**COMMITTEE OF THE WHOLE JUNE 18, 2001**

**SITE DEVELOPMENT APPLICATION  
LOBLAW PROPERTIES LTD.  
REPORT #P. 98.129  
FILE: DA.00.133**

<p>ATTACHMENT '5' ELEVATIONS</p>	FILE #:	REPORT #:	DATE: 28/05/01
	DA.00.133	LOCATION: PART LOT 19,20 CONC.5	SCALE: NOT TO SCALE
	CITY OF VAUGHAN PLANNING DEPARTMENT		APPLICANT: LOBLAW PROPERTIES LIMITED

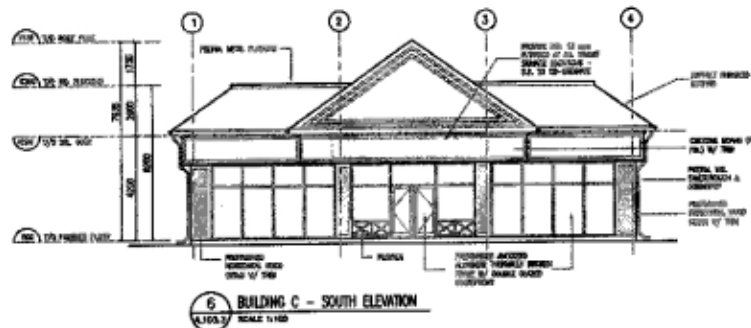
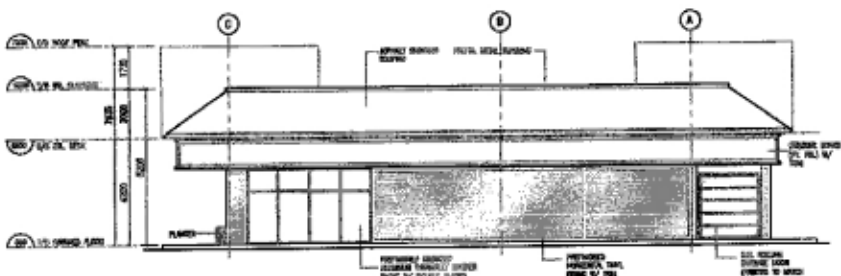
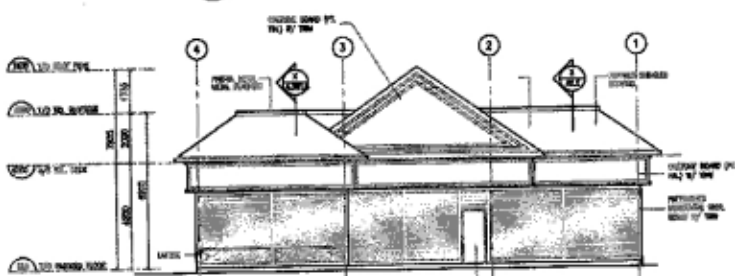
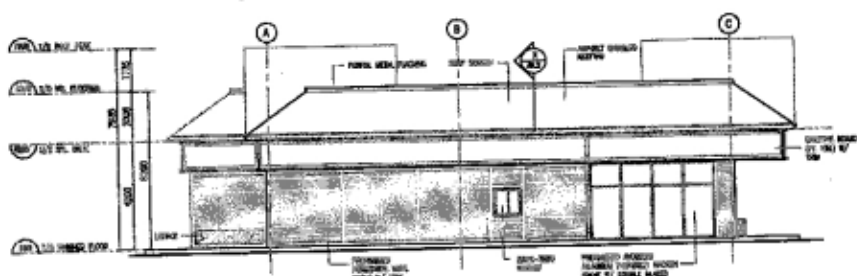
The exterior of Building “C” (eating establishment) is finished primarily with horizontal prefinished wood and vinyl siding and an asphalt shingle roof. The main front entrance of the building is oriented to the south, and a blank wall with 4 glass panels faces Major Mackenzie Drive. Staff recommend that the north elevation be upgraded to provide more visual interest along the Major Mackenzie frontage.

THAT the green metal roof of the *Tim Horton's* structure incorporate a more traditional roof in colour and fabrication, to be consistent with the overall development;

ATTACHMENT '6'  
ELEVATIONS

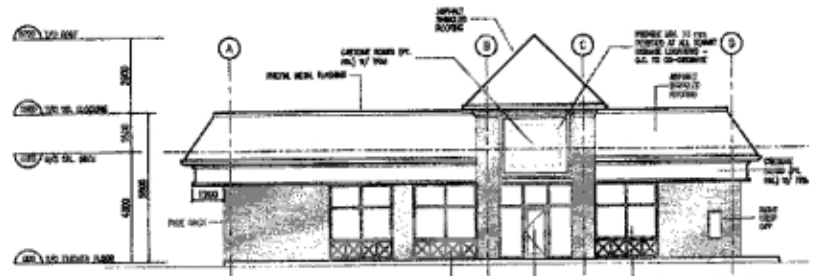
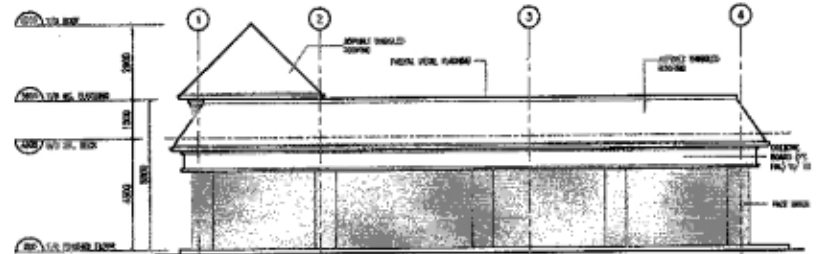
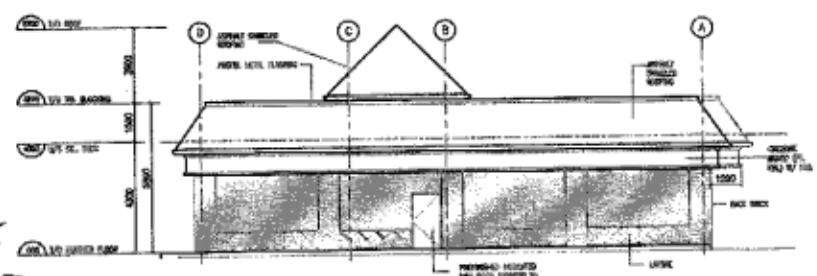
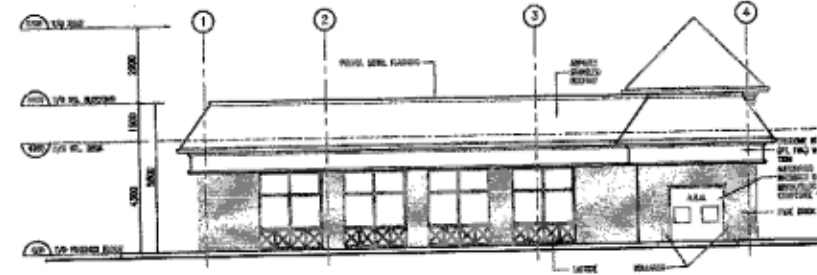
The one-storey bank (Building “D”) exterior is clad with a rust-coloured brick veneer and a light taupe accent stucco panels. A tower entrance structure is capped with an asphalt shingle roof. The main front façade is oriented westward and the Major Mackenzie Drive elevations include windows and an automated bank machine. Staff is satisfied with the proposed elevations.

ATTACHMENT '7'  
ELEVATIONS

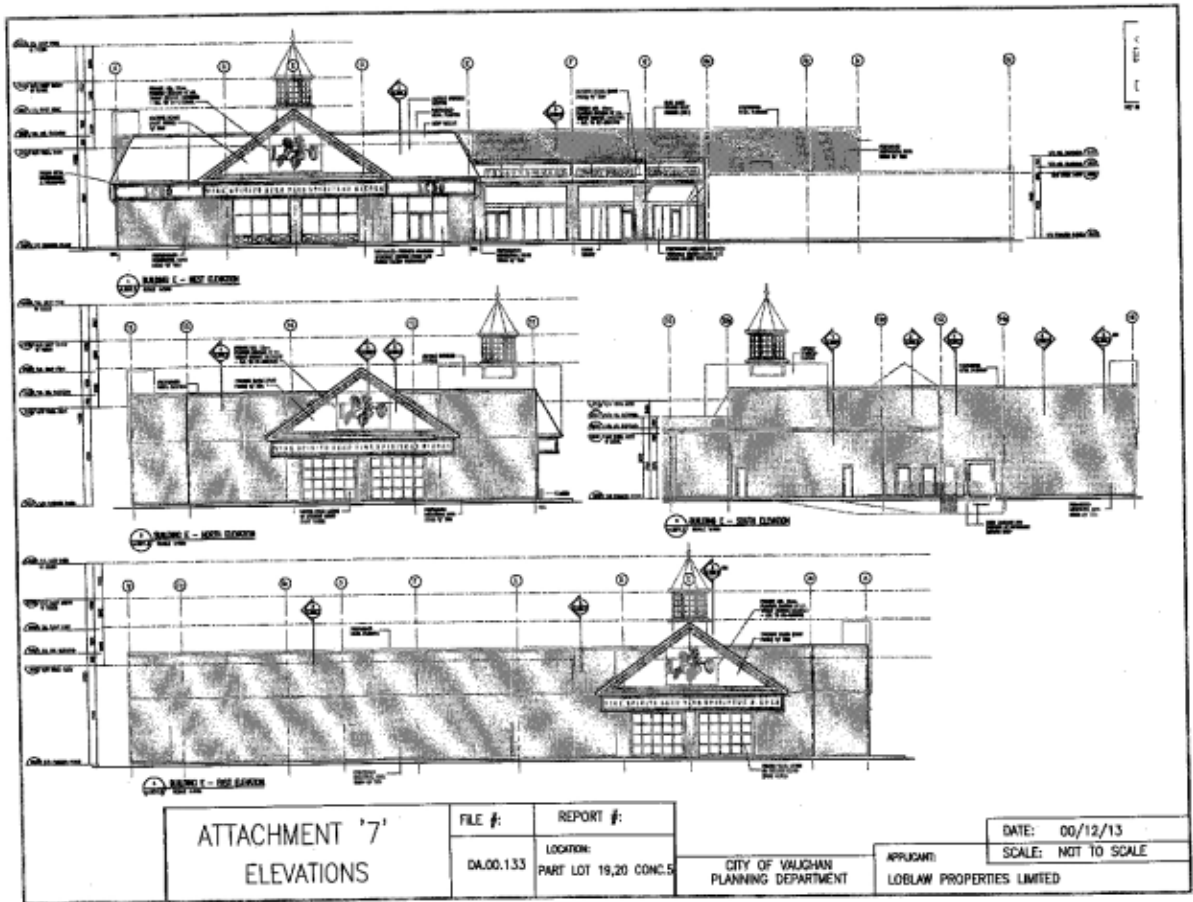
Buildings “E” and “F” are located in the southeast quadrant of the site with the main front entrances oriented towards the parking area. These buildings are one-storey to a maximum height of 7.9m for the main building. The building exteriors will be finished with horizontal wood and vinyl siding, glazed windows and asphalt roof shingles. A tower structure complements the main front elevation of each building. The rear elevations of these buildings will face an approved residential subdivision and therefore, should be upgraded to be more visually appealing.
